## Access Compliance Report Public Rights-of-Way (Curb Ramps)

Intersection ID: 27770Main Street:BREM\_LNCross Street:COUNTS\_PLLocation:WADA ID: B999180E988DRamp Type:PerpInitial Pass/Fail:FailOverall Compliance:NoSeverity Score:12.5

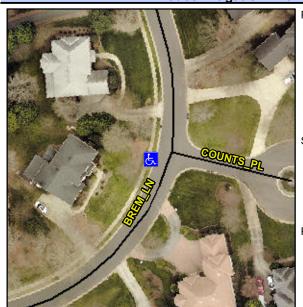
R304.5.3

Field Measurements/Component Compliance					
Compliance Description		Data		oliance Description	Data
N/A	Ramp Length (in)	96.0	Yes	Ramp Slope (%)	5.1
Yes	Ramp Width (in)	94.0	No	Ramp XSlope (%)	5.3
N/A	Flare Type LT	N/A	N/A	Flare Type RT	N/A
N/A	Flare Slope LT (%)	N/A	N/A	Flare Slope RT (%)	N/A
N/A	Flare Traversable LT?	N/A	N/A	Flare Traversable RT?	N/A
N/A	Landing Length (in)	N/A	N/A	DWS Provided?	N/A
N/A	Landing Width (in)	N/A	N/A	DWS Contrast?	N/A
N/A	Landing Slope (%)	N/A	N/A	DWS Length (in)	N/A
N/A	Landing X Slope (%)	N/A	N/A	DWS Full Width?	N/A
N/A	Landing Curb? (Y/N)	N/A	N/A	DWS Offset (in)	N/A
N/A	Shared Landing?	N/A			
N/A	Gutter Ponding?	N/A	N/A	Gutter Slope (%)	N/A
N/A	Gutter Lip Ht (in)	N/A	N/A	Gutter X Slope (%)	N/A
N/A	Painted X Walk1?	No	N/A	Painted X Walk2?	N/A
	X Walk 1 Direction	To SE		X Walk 2 Direction	N/A
N/A	X Walk 1 Width (in)	N/A	N/A	X Walk 2 Width (in)	N/A
	X Walk 1 Slope (%)	4.8		X Walk 2 Slope (%)	N/A

Remove & Replace Entire Ramp.
